# **Appendix A**

## **NDEP and TRONOX Correspondence**

Re: **Kerr-McGee Chemical Corporation LLC (KM)**  
**NDEP Facility ID #H-000539**  
Nevada Division of Environmental Protection Response to:  
*Supplemental Phase II Report – Environmental Conditions Assessment*

Re: **Kerr-McGee Chemical Corporation LLC (KM)**  
**NDEP Facility ID #H-000539**  
Nevada Division of Environmental Protection Response to:  
*Background Investigation Work Plan* dated March 29, 2005

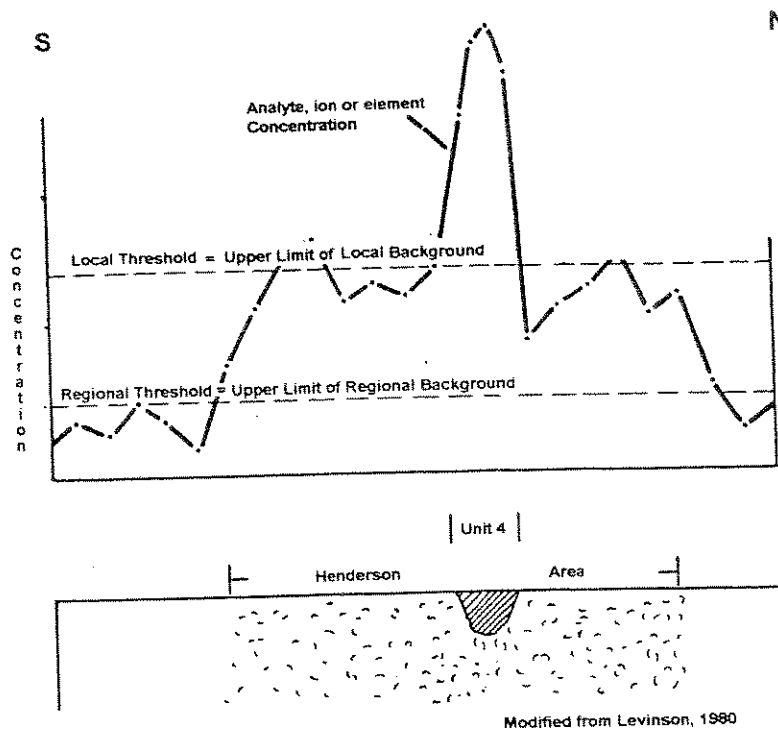
1. General comment, CEM Jurat, the jurat should clarify who is the responsible CEM for this project. There are three signatures on the page and one of the signatures is by a non-CEM. Please revise.

*The signature page has been revised.*
